Subject: Submittal of Additional Information Concerning Remediation Activities at the
Westinghouse, Waltz Mill Site, Madison, Pennsylvania
License No., SNM-770, Docket No. 07000698

**Response to NRC Letter Dated August 10, 2001
Request for Additional Information
Concerning Remediation Activities**

**Waltz Mill Site
Madison, Pennsylvania**

**Response to NRC Letter Dated August 10, 2001
Westinghouse Electric Company, LLC
Request for Additional Information
Concerning Remediation Activities at the
Westinghouse Waltz Mill Site
Madison, Pennsylvania**

**FIGURE A-1
FORMER GROUNDWATER PUMP
AND TREAT SYSTEM LAYOUT
WALTZ MILL SITE
MADISON, PENNSYLVANIA**

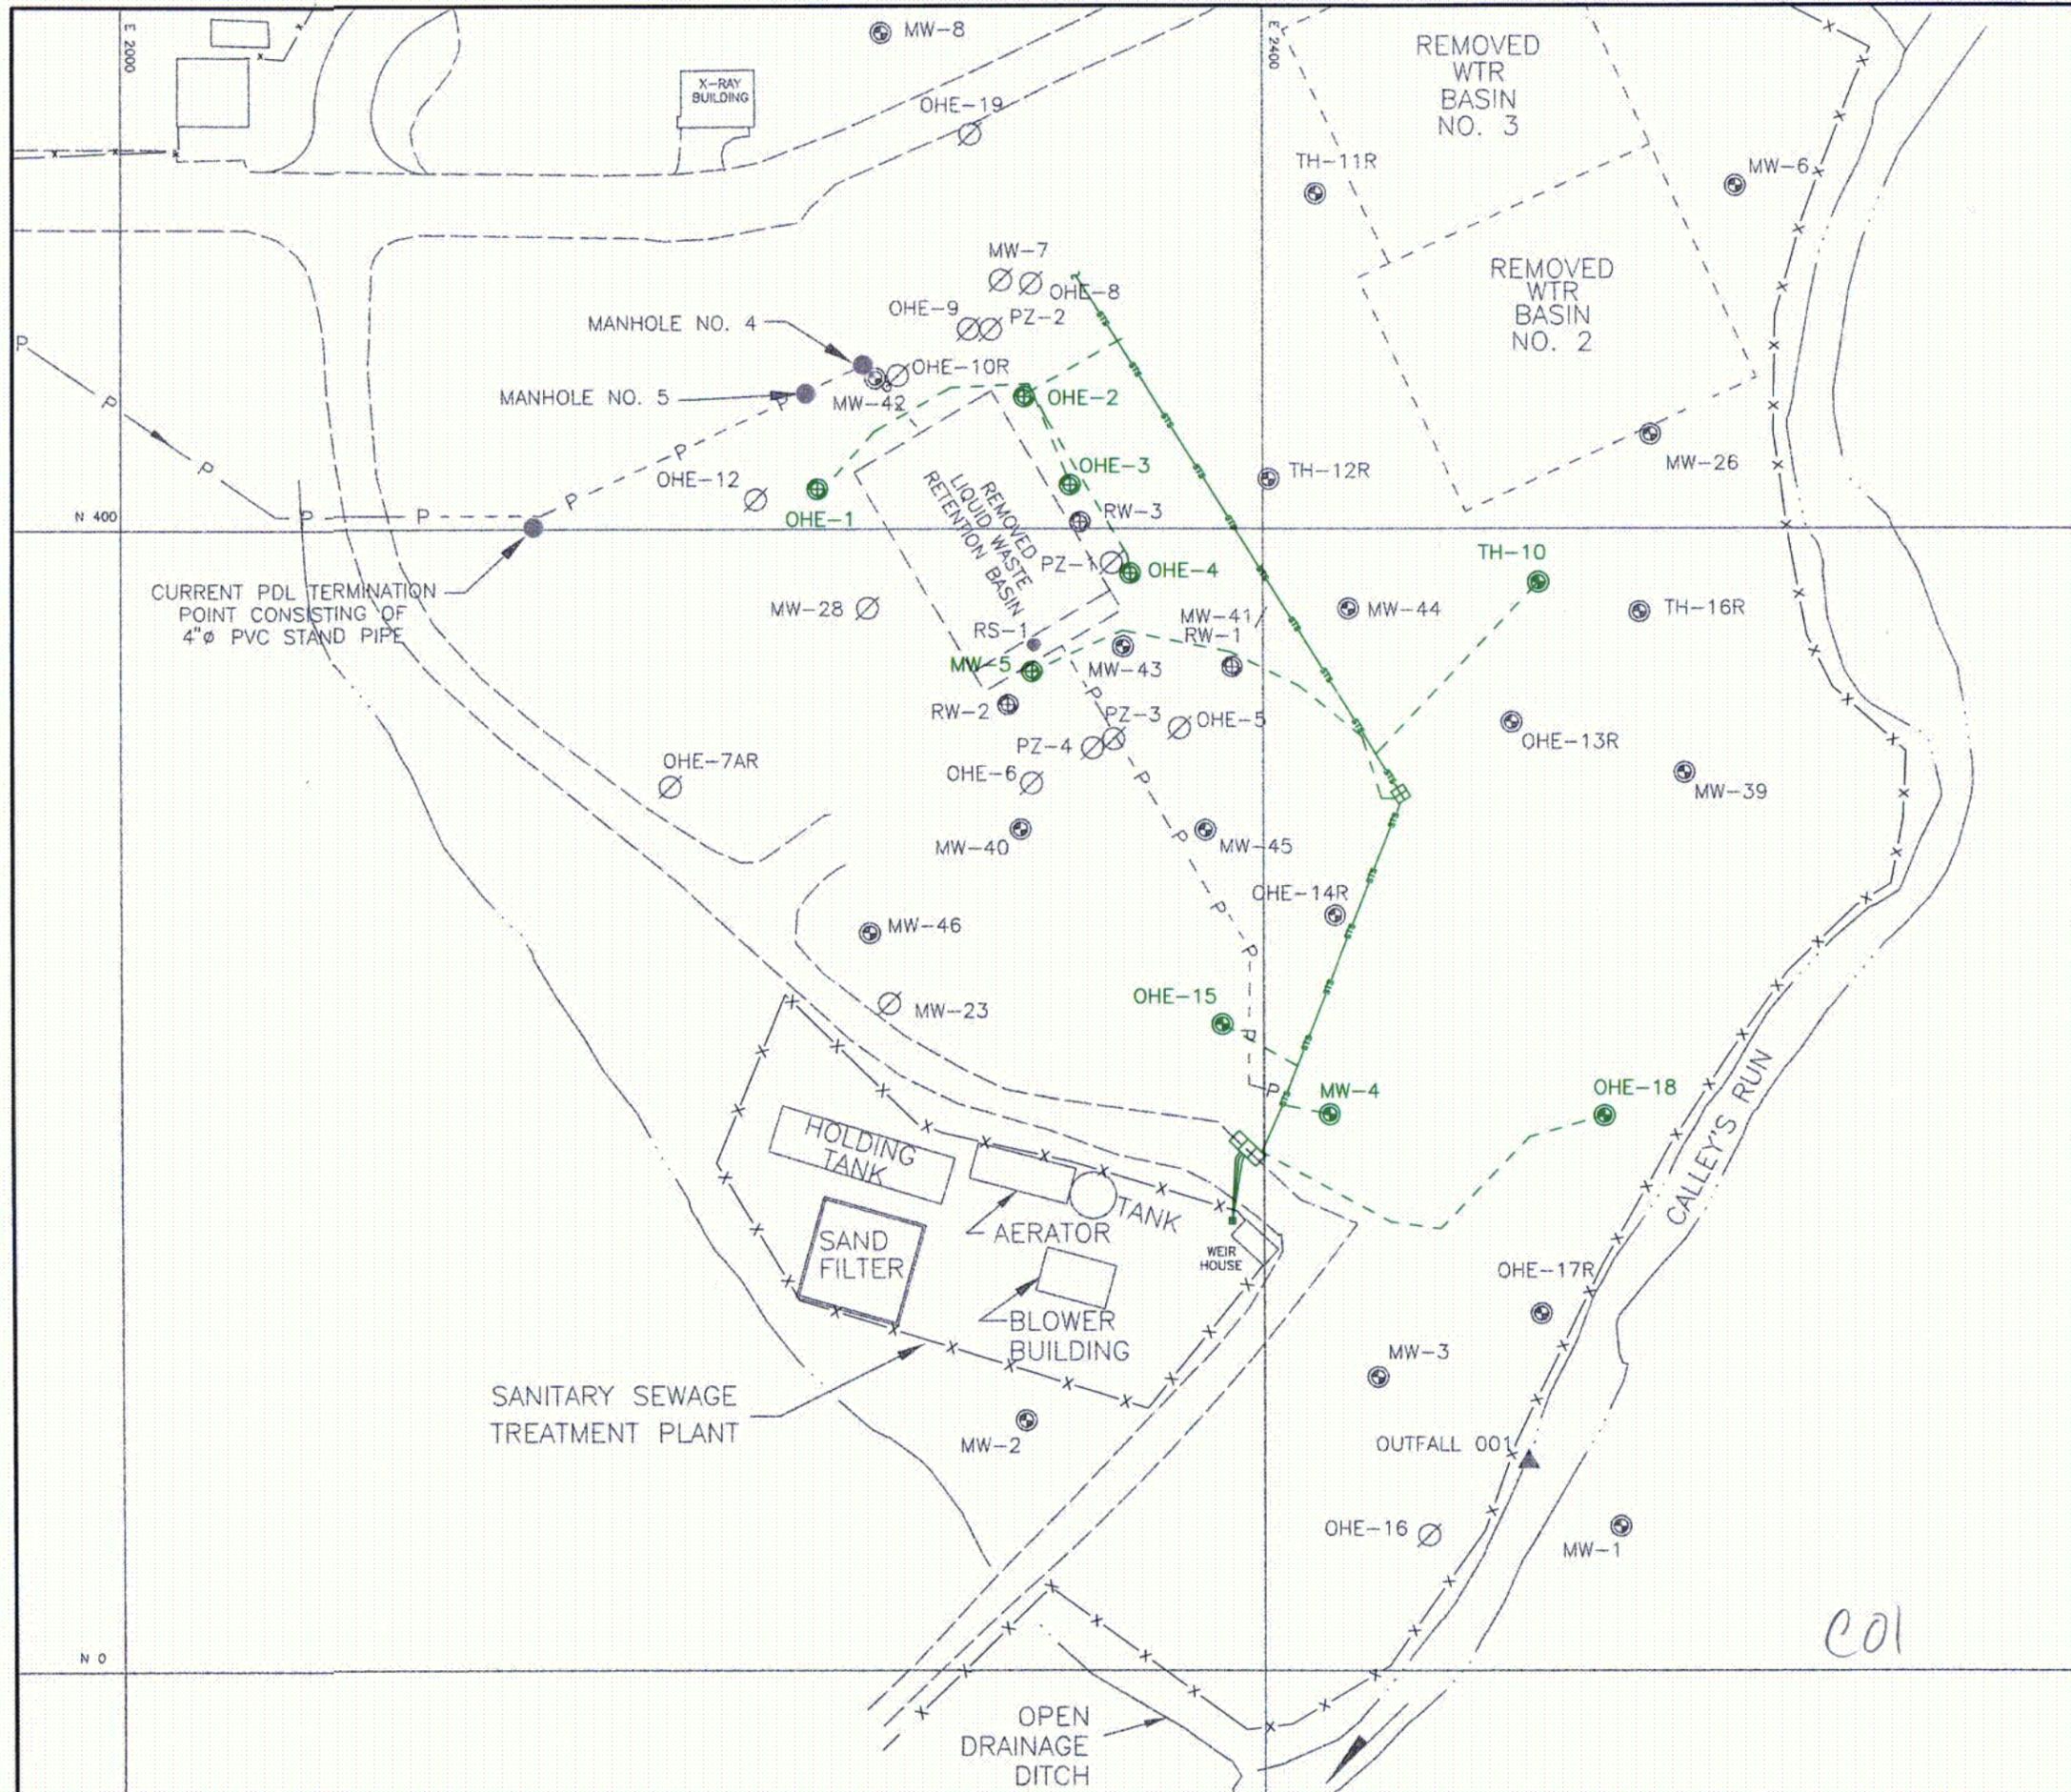
Question No. 4a: The current groundwater pump and treat system has resulted in several measurable groundwater cones of depression; however, there is no verification of containment of the plume. Please provide verification of groundwater containment, such as through particle tracking analysis, as we discussed during our meeting.

The following paragraphs provide a summary of the groundwater remediation system before and following soil remediation activities. Figure A-1 of Attachment A illustrates the groundwater pump-and-treat system that was in place before the implementation of soil remediation activities. The pumping wells consisted of OHE-1 through OHE-4 and MW-5. As outlined in the license amendment dated June 22, 1999, these wells were permanently removed during remediation since they were located in areas of soil contamination requiring excavation. Prior to remediation, two new wells were installed (MW-40 and MW-41) immediately hydraulically downgradient of this area (Figure A-1) for monitoring purposes and potentially as pumping wells, if they were required to contain the plume. To ensure the plume was contained during soil remediation activities, it was decided to use Well MW-41 as a pumping well during soil remediation activities.
